Re: Minor Project Refinement No. 11 for the TL 6975 San Marcos to Escondido Project

TL6975 San Marcos to Escondido 69 kV Project CPUC Minor Project Refinement Form

**TL6975 SAN MARCOS
to ESCONDIDO PROJECT**
MPR 11
Additional Temporary Work Area
San Diego County, CA

ATTACHMENT B
MPR-11 Figure

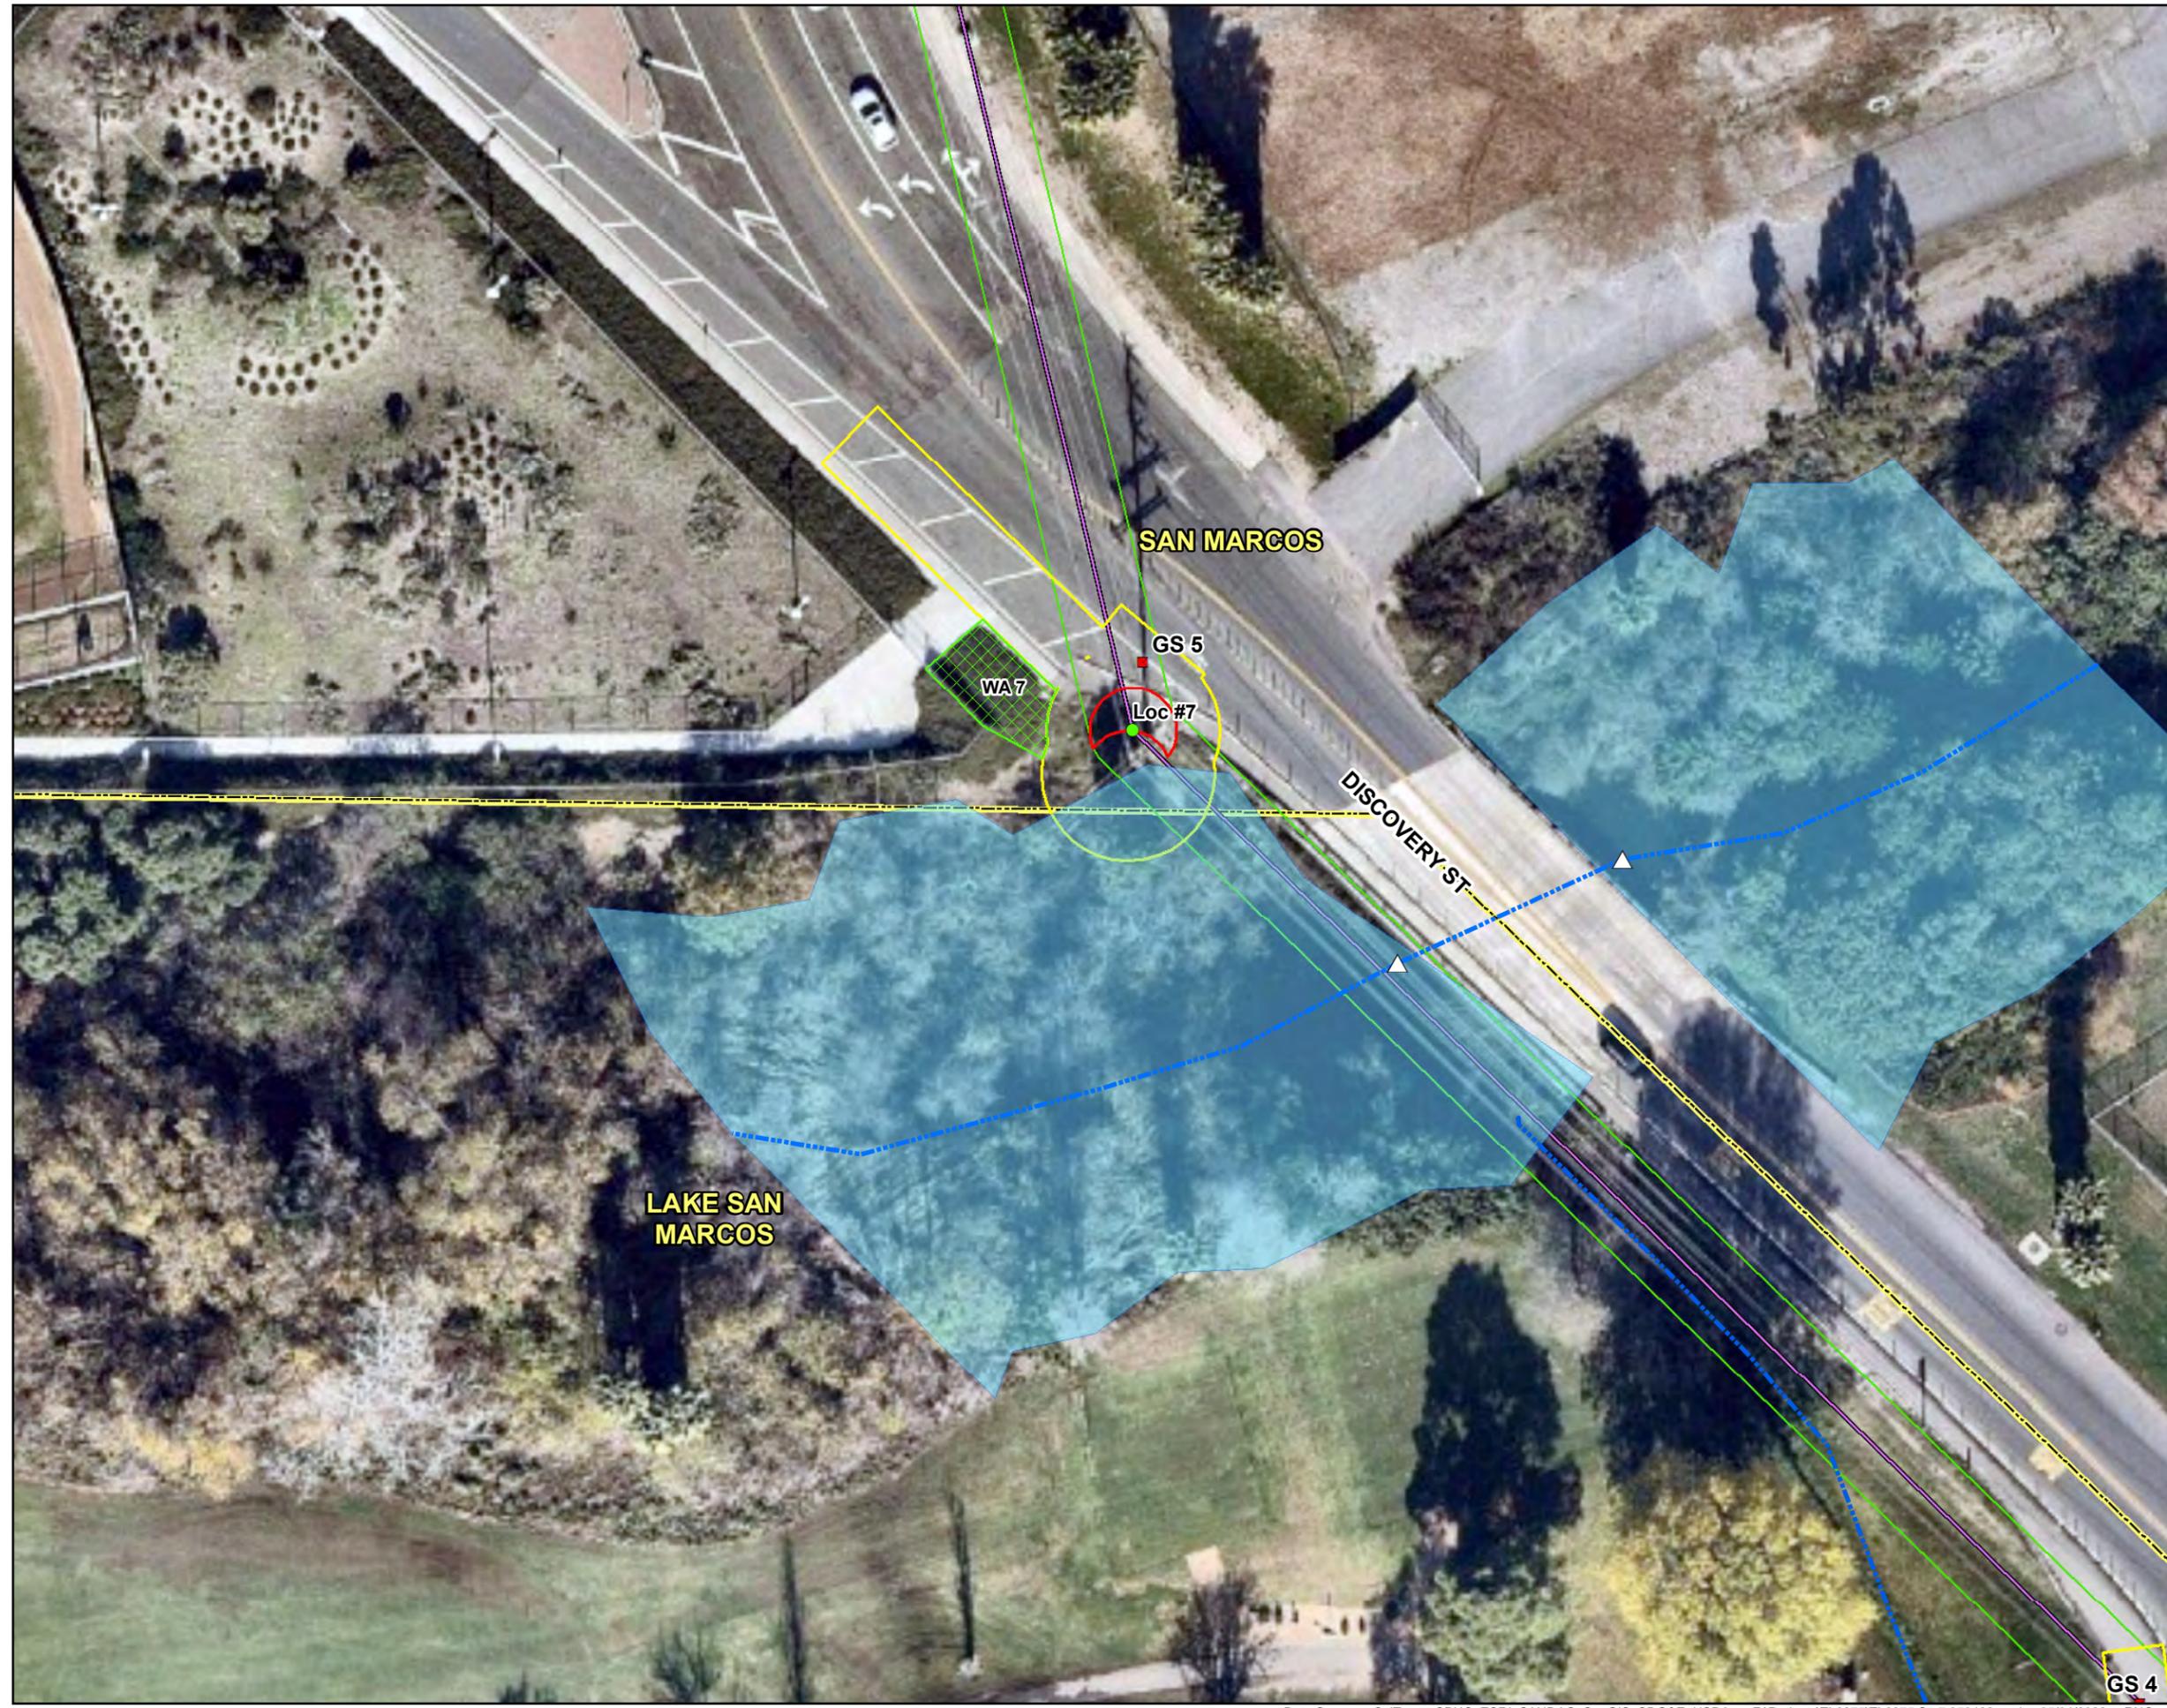
- **Location 2.1 Additional Work Area (WA 2.1):** WA 2.1 is a circular work area with a 10-foot radius around Location 2.1. Location 2.1 is changing from a designation of “No Work/Information Only” (as shown in the NTP-1 Mapbook) to “Overhead Work” as overhead fiber work will likely be required at this location. The overhead work would be performed from the street using a bucket truck. The location of the bucket truck and associated traffic control will be determined in the forthcoming right-of-way (ROW) Permit and Traffic Control Plan issued by the County of San Diego. No vegetation trimming is anticipated within WA 2.1.

- **Location 3 Additional Work Area (WA 3):** WA 3 is immediately northeast of Stringing Site 01 and southeast of Location 3 on SDG&E property. This expanded work area will be utilized to position equipment (water truck, drill rig, etc.) during pole installation and wire pulling activities at Location 3. Within WA 3 and along the perimeter of San Marcos Substation, there is landscaping planted by SDG&E comprised of African sumac trees, juniper shrub understory, and mature olive trees. Three African sumac trees and the juniper shrub understory will need to be removed (grubbed), and two mature olive trees will need to be trimmed (see **Attachment C** for an overview of vegetation). The African sumac tree removals would take place using a chainsaw and a skid steer or similar equipment. Stormwater Pollution Prevention Plan (SWPPP) BMPs would be installed to prevent off-site sedimentation in areas where the vegetation is being removed or grubbed.

- **Location 7 Additional Work Area (WA 7):** WA 7 is located west of Location 7 immediately adjacent to the approved work area for Location 7. The additional work area will be utilized to stockpile spoils from the foundation excavation for the pier foundation at Location 7. A silt fence will be installed around the perimeter of WA 7 to protect from any runoff into the nearby jurisdictional aquatic feature. The ornamental acacia shrub within WA 7 will be trimmed down to create space for the spoils stockpile. SDG&E has received approval from the property owner (San Marcos High School) to trim the ornamental vegetation within WA 7. Vegetation trimming would be completed with both hand tools and a skid steer with a mower deck and would be no less than 4 inches above the ground to maintain the root structure and seed bank per the SDG&E Natural Communities Conservation Plan (NCCP) Operational Protocol No. 36 (Section 7.1).

Photograph 2:
View of the additional temporary work area at Location 3 (WA 3) and Stringing Site 01. An overview of vegetation removal at this location is shown on Photographs 3-5. Facing: SE.

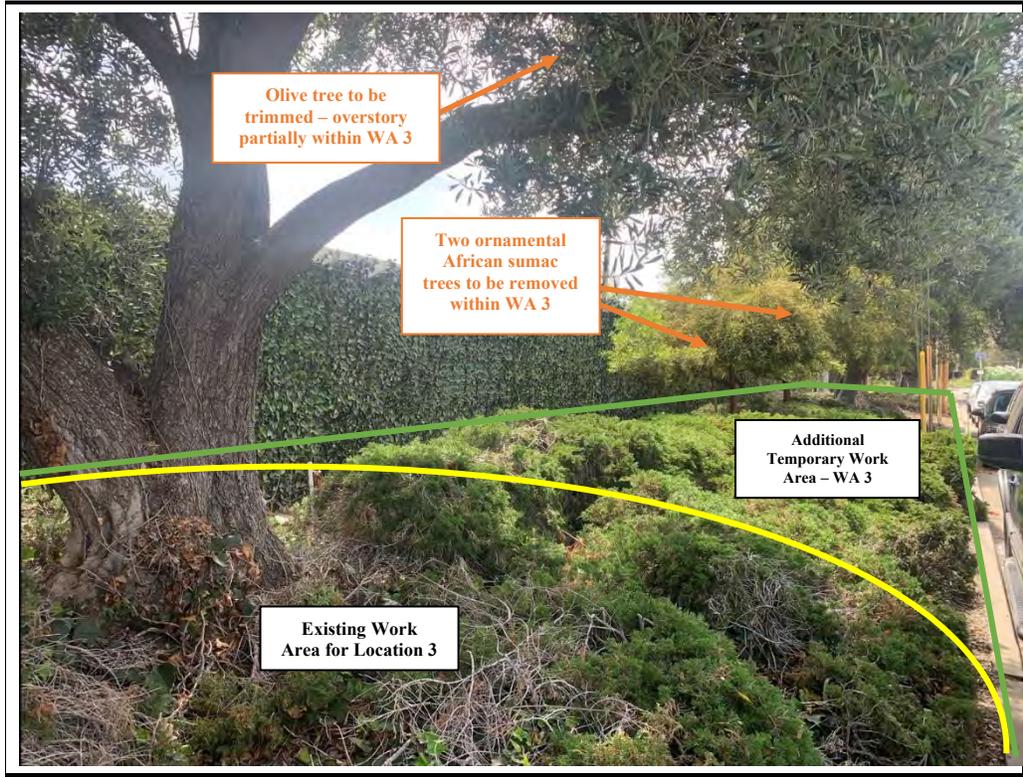
- **WA 3:** WA 3 will be required to stage equipment such as a water truck and drilling equipment, which will be utilized during drilling and foundation installation activities. Utilization of WA 3 for this work will allow the equipment to be stored overnight within the construction fencing. In addition, WA 3 is needed to manage the anchors for Location 3, as well as laydown of wire spools and equipment during wire pulling activities within Stringing Site 01.
